P 516530

**ON-SITE SEWAGE DISPOSAL SYSTEM
HOWARD COUNTY HEALTH DEPARTMENT
BUREAU OF ENVIRONMENTAL HEALTH**

ADDRESS: 2972 Jennings Chapel Rd., Woodbine PROPERTY OWNER: Steven & Maija Kropp

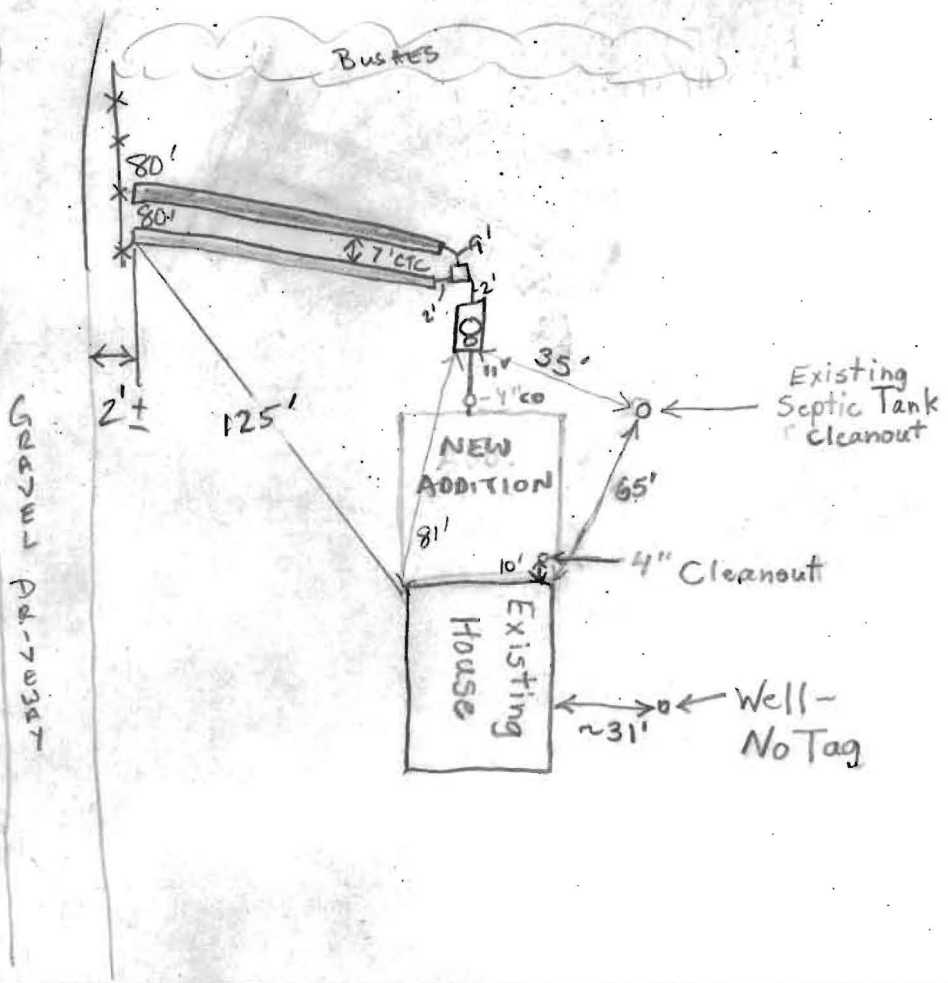
PRE-CONSTRUCTION 3/5/02 To install two trenches 20' from proposed addition that run towards the left rear of the property. (BB)

INSTALLATION 3/12/02 Trenches 7' CTC @ 80' long each. OK TO COVER D.B & trenches. Needs baffle on front side of S.T. T.W. New worker for Herman. Nice job! Measurements accurate. OK TO CONTINUE WORK (KG) 11/08/02 KN called Herman Sirk for any final information re-connected to house where? owner called today for old well information - none available. (KN) 11/13/02 - PER OWNER MR. KROPP, PLUMBER CONNECTED TANK TO ADD. AT OR AROUND 3/12/02; OK

2972 JENNINGS CHAPEL ROAD

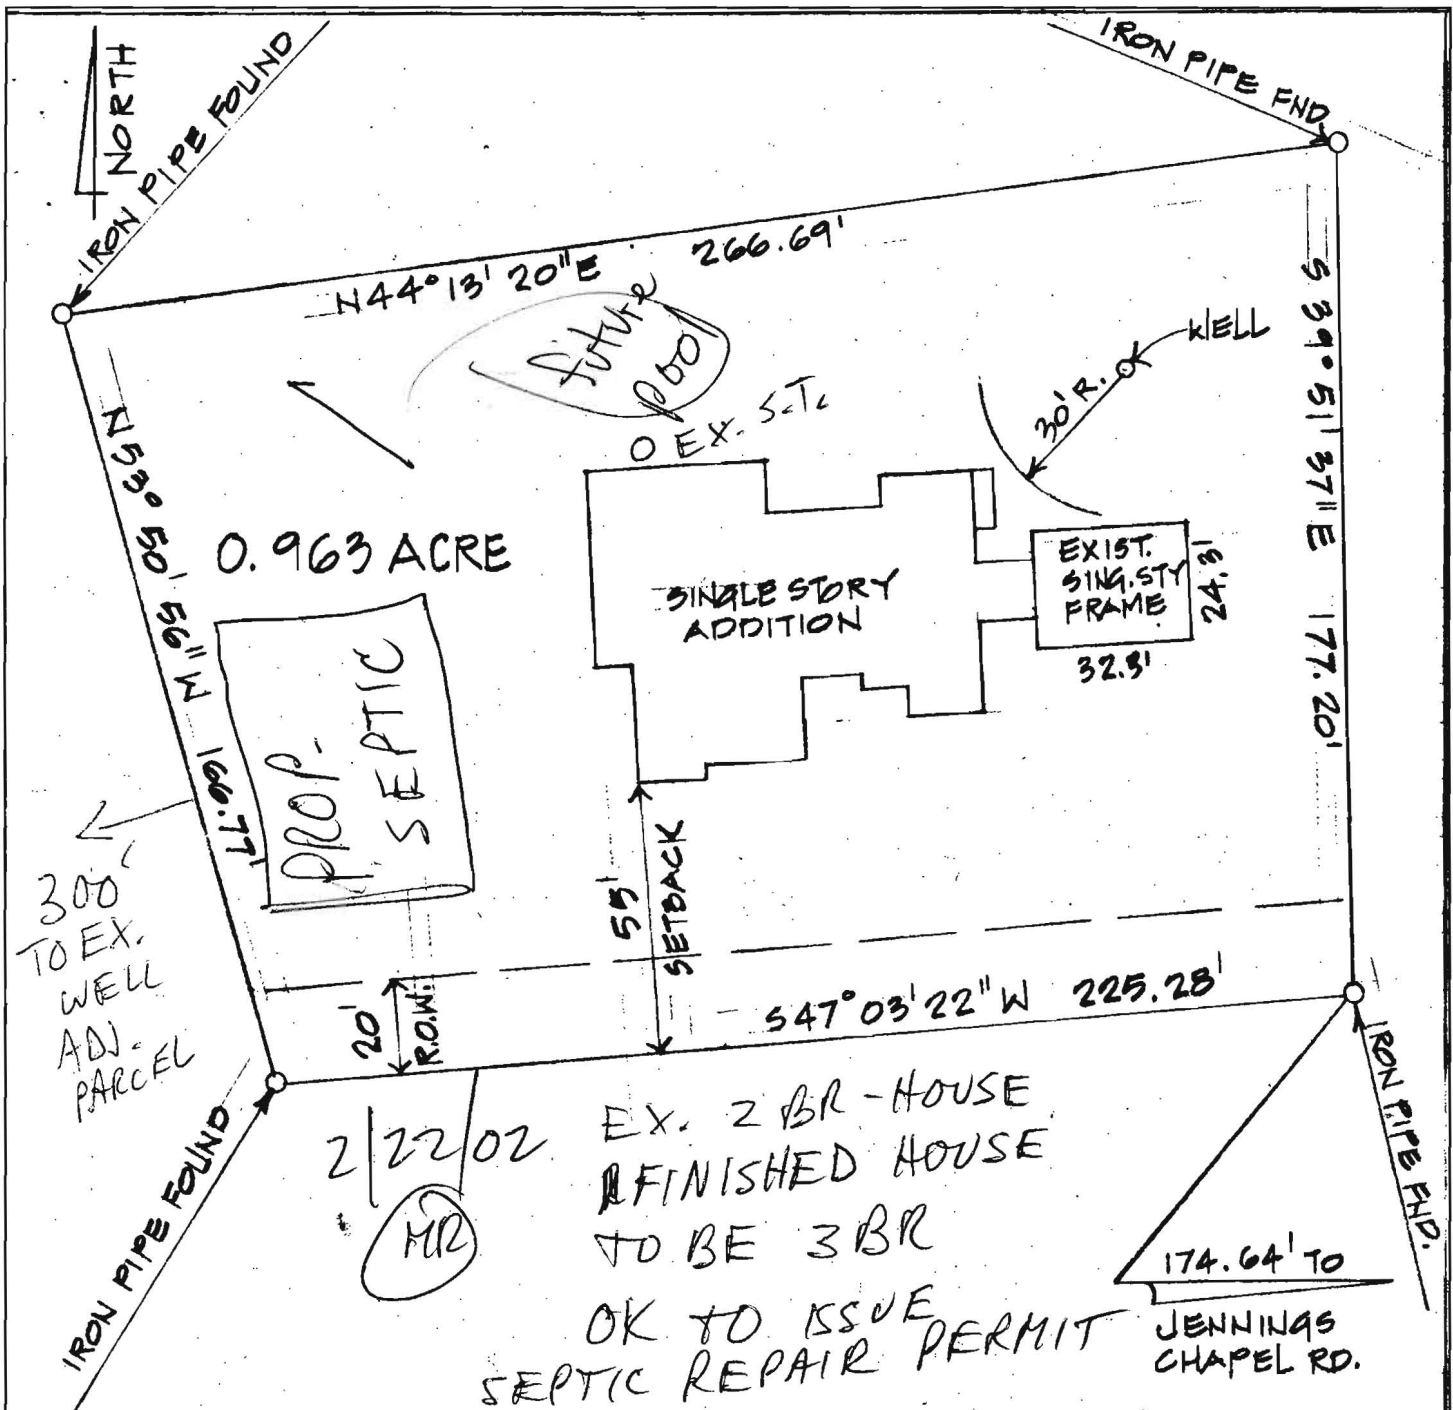
EX. 2 BR - HOUSE
 FINISHED HOUSE
 TO BE 3 BR
 OK TO ISSUE
 SEPTIC REPAIR PERMIT
